RE: TEDS Exception No. 34-03, for a New Access onto Rimrock Drive

**DESIGN EXCEPTION #DE34-03**

RE: Request for Exception for a New Access onto Rimrock Avenue

# **TEDS EXCEPTIONS REQUEST**

# EXHIBIT 1

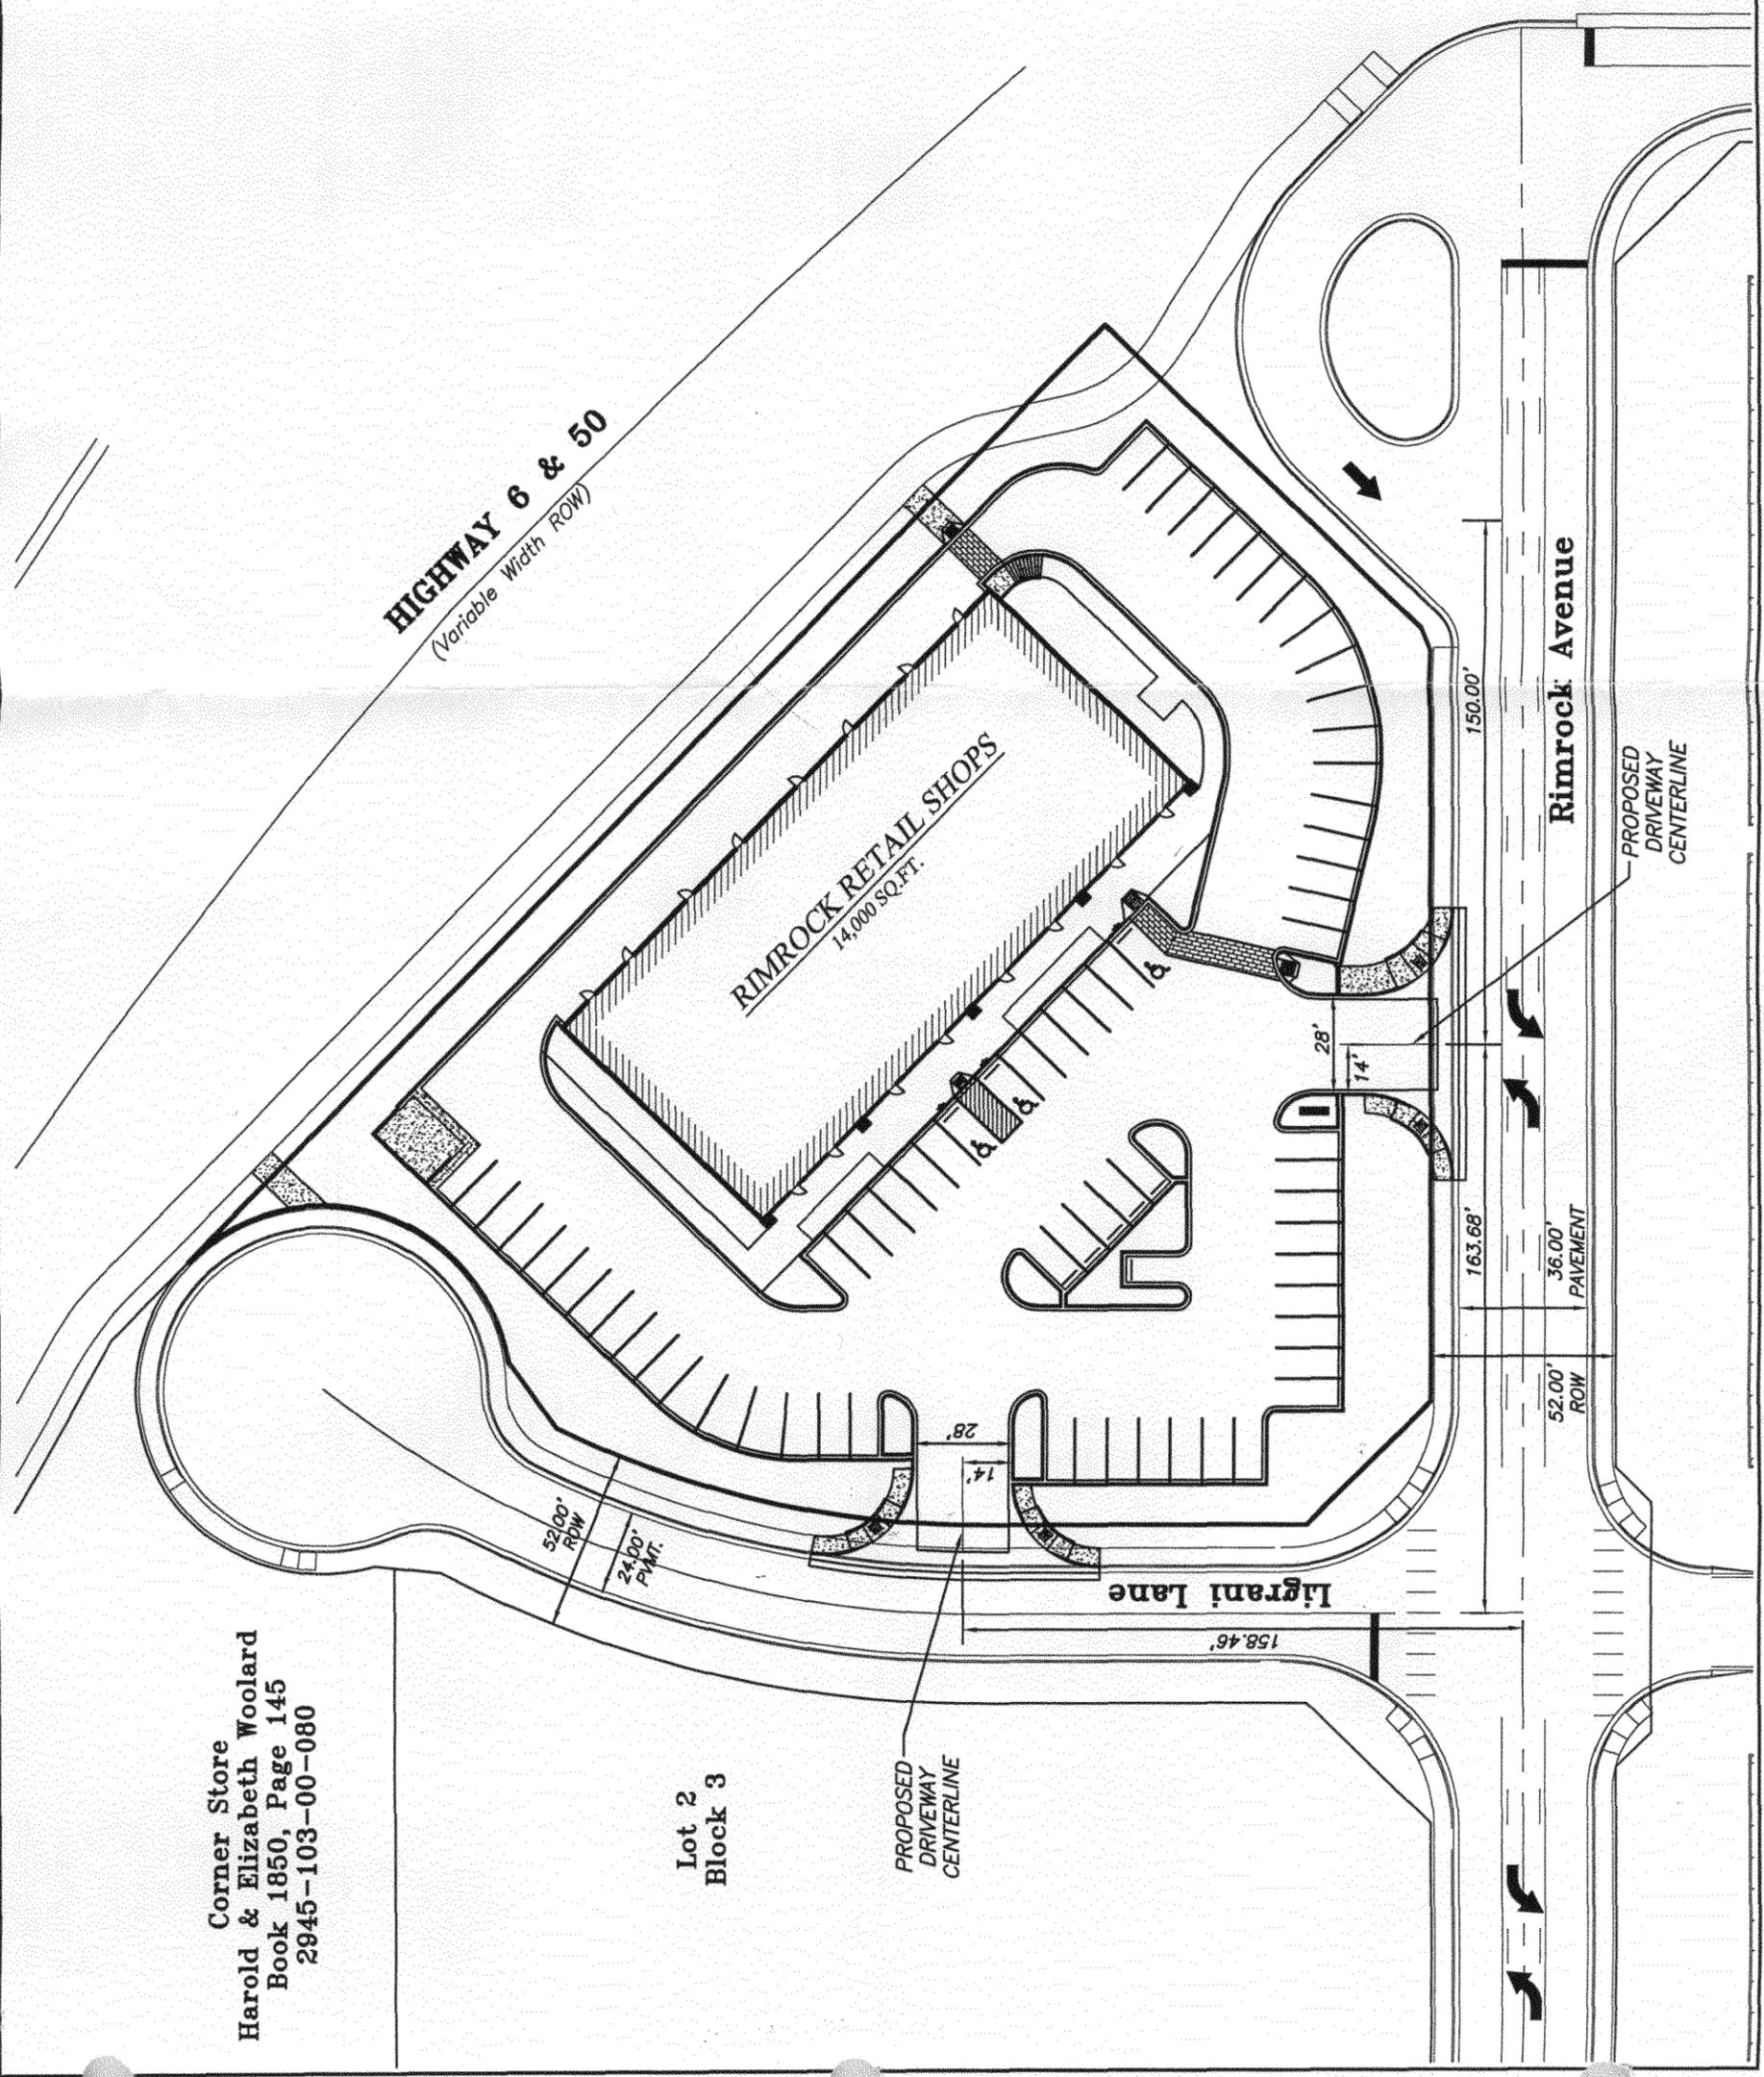
Exhibit 1 shows the proposed layout and access locations for the site. The access that is not allowed per staff review comments is the one to Rimrock Avenue. This access, as shown here, meets all spacing requirements per the TEDS Manual. This access is approximately 165' from the Ligrani Lane intersection, and it is exactly 150' from the bus turn around on Rimrock Avenue to the east. In addition, there are no other accesses along the south side of Rimrock Avenue that are in conflict with this proposed access location. These access points as described here, with the key dimensions are shown on the proposed layout. Following is discussion regarding the TEDS Manual requirement and justification for the access location as proposed.

be allowed based on traffic safety as determined by a TIS as described in Chapter 2." Per the enclosed traffic estimates for this type of use from Wolverton & Associates, the peak inbound trips are 16 and the peak outbound trips are 21. See Exhibit 2. This is the total peak trips for the entire site, not just the proposed Rimrock Avenue access. The speeds on Rimrock Ave will be below design speeds at this location due to the tight 90 degree turn in the road at the intersection of Rimrock Avenue and 25 1/2 Road. This access location meets all design and safety standards for spacing.

Rimrock Avenue also is striped with a designated left turn lane for the entire length of the street frontage of this property. Therefore, there will not be any effect on eastbound Rimrock Avenue traffic turning into the site, due to this designated left turn lane. It would be anticipated that the majority of the traffic entering this site would be eastbound traffic, which has the designated left turn lane. Also the majority of the traffic leaving this site would be westbound traffic that would utilize a right turn out of this access.

We feel that this access provides a benefit to the site by allowing additional access points and improved traffic flow through the site for the fire department. This site is not big enough to allow a fire truck to turn around within the site. Because of that, the fire fighting ability for this site would be limited to the 150' fire truck route entering from the Ligrani Lane access and the 150' hose length per the fire department. This means that part of the south and part of the east side of the building would have little or no fire protection.

As the site is designed the Fire Department would require that both access points remain. Complete access around the building for Fire Department Vehicles is not adequate and if the access from Rimrock Ave. is removed it would create a dead end access for Fire Department Vehicles in excess of 150 ft. and the site would have to be redesigned.

(NE Corner of Rimrock/Ligrani - proposed Commercial Site with desired access points on both Rimrock and on Ligrani. Proposed Rimrock access is about mid way between Ligrani and the bus turn around exit.)

I had reviewed this site with Kevin Knott of LanDesign in an isolated review, not aware of the surrounding proposals (or limitations) for area Rimrock access points. I reviewed it from the standpoint that it may be of benefit to emergency access, that it did meet access spacing requirements for this class of road, and that a second access would not pose a cut-through opportunity, as Ligrani is a dead end road.

I saw no problem with a second access, but feel the site could also function with a single Ligrani access. Please put me down as a neutral on this issue, and would only shift to an approval if the Fire Dept wished a second access for the site..

Personally, I question the need for this access. Why can't they all use the cul-de-sac access? If this is the only access onto Rimrock Avenue, I would like to maintain the status quo. Why does this building need this access more than Lowe's or Super Wal-mart or Mr. Wollard's RV Sales? Is there any problem with conflicts between this traffic and traffic turning the corner at 25 1/2 Road? If this access is not there, will people have trouble finding these stores? I don't think many of the customers for these shops will be driving along 25 1/2 Road and suddenly realize they have to stop and buy something. If so, there is probably not enough traffic on Rimrock and 25 1/2 road to support these stores for long. Even if someone does suddenly need to stop here, it is easy westbound access from the cul-de-sac. East bound traffic, if they miss the cul-de-sac, can easily use the "bus turnaround" to quickly return.

Is the fire access issue real or do they need to design their project from the outside in to determine where the building works best and how large of building fits on the site?

The Minor Collector is the lowest level of Major Street and its generally recognized purpose is to transport vehicles with some property access. This Minor Collector has been over sized by providing a center left turn lane. The spacing meets the requirements for a Collector Street. The site does take its primary access from Ligrani Lane. Because of the right angle turn 150 feet to the east, speeds along this stretch of Rimrock should be pretty low.

Because of the shape of the lot that these developers created, a building which meets all of the City's design standards would be very small. It would probably only be about half of the proposed size. The site could be re-designed to meet all of our standards, but I think that this plan mitigates any potential safety issues do to the configuration of Rimrock Avenue and their access spacing.

The Fire Department believes that the absence of this access would be a serious safety issue due to limited capability to cover all of the proposed building. Sprinkling the building might mitigate this issue, but this driveway is probably a more reasonable solution.

I recommend approval of the requested Design Exceptions to Section 3.2.2 to allow the proposed secondary access to Rimrock Drive.
